## Committee of the Whole Report

**Subject:** Development Permit with Variances Application No. 000543 for 975 and 983 Pandora Avenue

**Figure 1:** 1:5 setback ratio along Vancouver Street

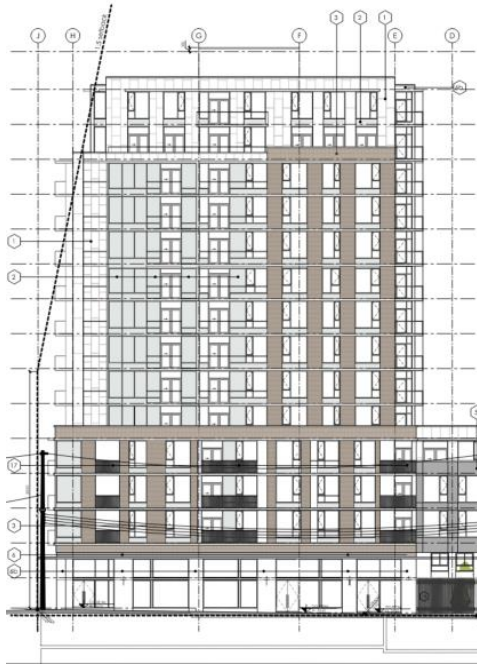
The upper storeys on levels 12, 13 and 15 encroach into the 1:5 building setback ratio along Vancouver Street as shown in Figure 1 below. However, staff consider these to be relatively minor in nature, since parapets, cornices, guardrails or other architectural elements are excluded. Similar minor encroachments exist for the Pandora Avenue frontage as shown in Figure 2.
